**Building Permit Application**  
Howard County Maryland  
Department of Inspections, Licenses and Permits  
3430 Court House Drive  
Permits: 410-313-2455  
www.howardcountymd.gov

Permit No.: B17002675

Existing Use: Vacant Lot  
Proposed Use: New Single Family Dwelling  
Estimated Construction Cost: \$ 455,505  
Description of Work: Building SFD

Subject: Project name Provisional Parcel A / Ambs  
Project site address 14247 Buxtonwoods Rd  
Permit # 1317002675 SDP # \_\_\_\_\_  
Other information pertinent to this project \_\_\_\_\_

WELL BOX REVISED  
PER HEALTH DEPT

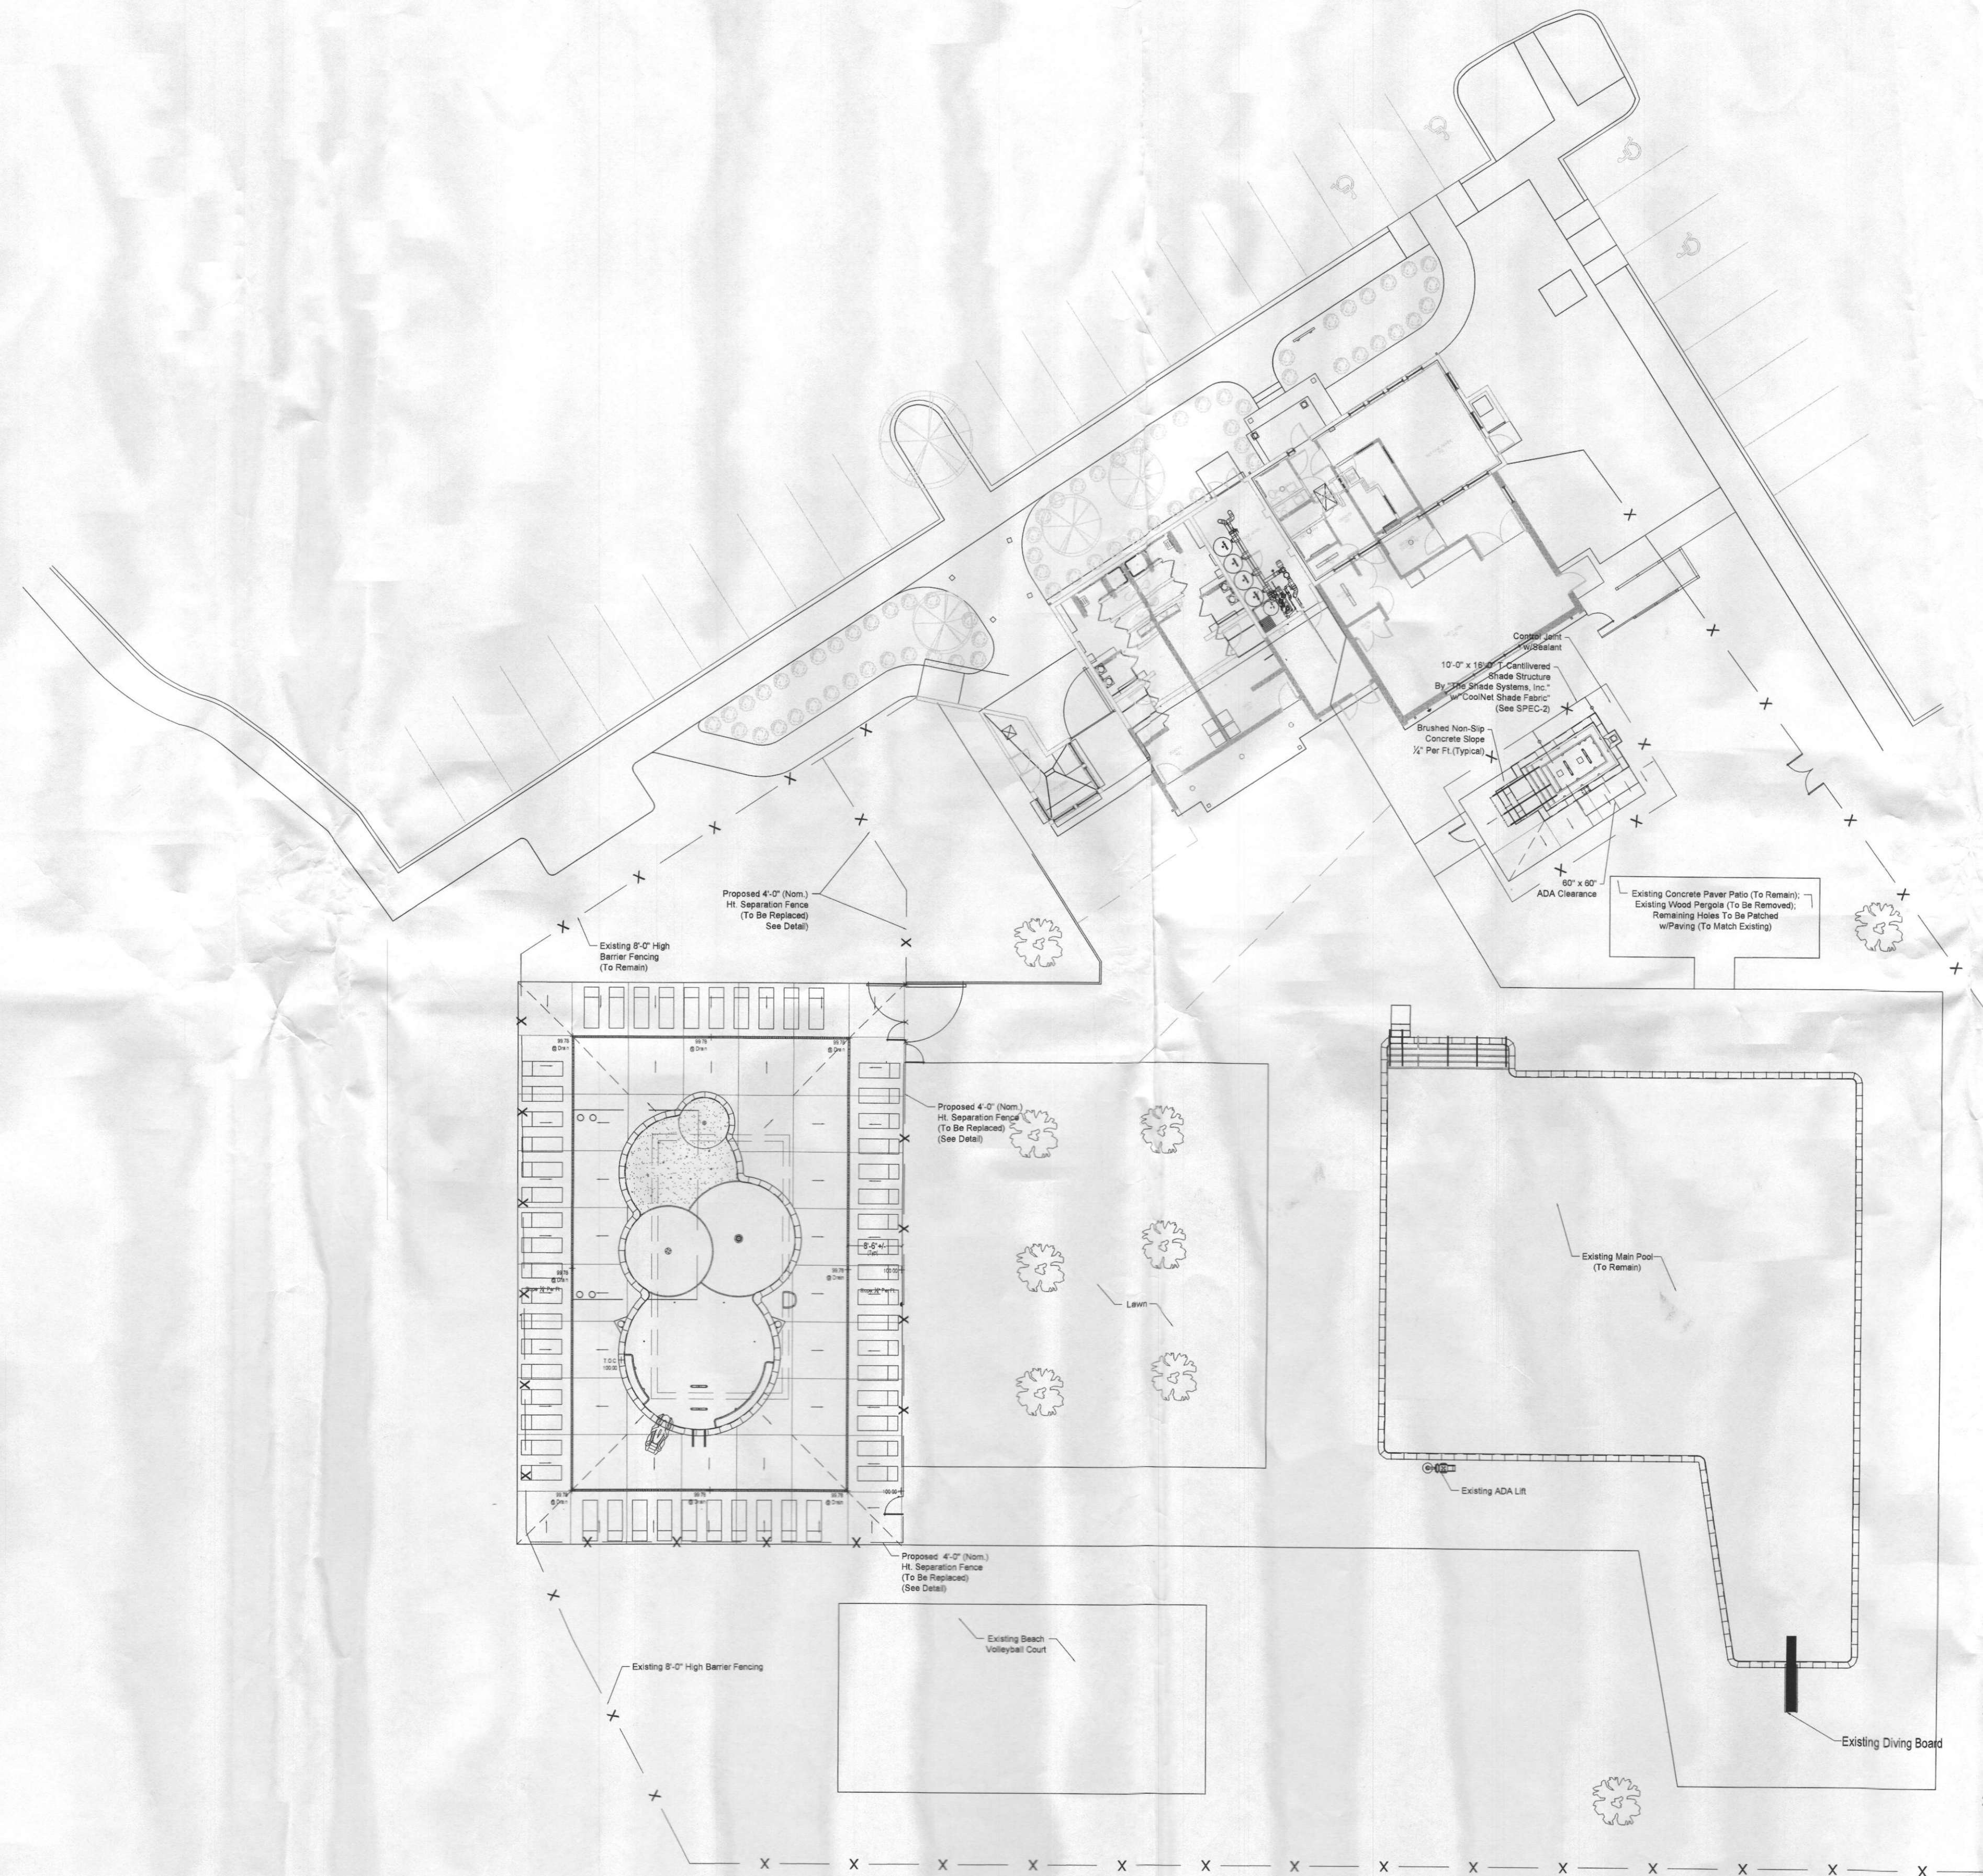
I have reviewed the floor plans in support of Building Permit **B17002675** for a new home at **14347 Burntwoods Road** (Maplewood Farms Buildable Preservation Parcel 'A') and noted that there is a rough-in for a full bathroom in the unfinished basement. Please note that this makes it very likely for one or more rooms to be considered bedrooms upon conversion of the basement to finished living space. As Buildable Preservation Parcel 'A' is connected to the shared sewage system and has a **four-** bedroom limitation, any future building permit for converting all or a portion of the basement into finished living space may be denied by the Health Department if the resulting total number of proposed bedrooms in the dwelling is above four.
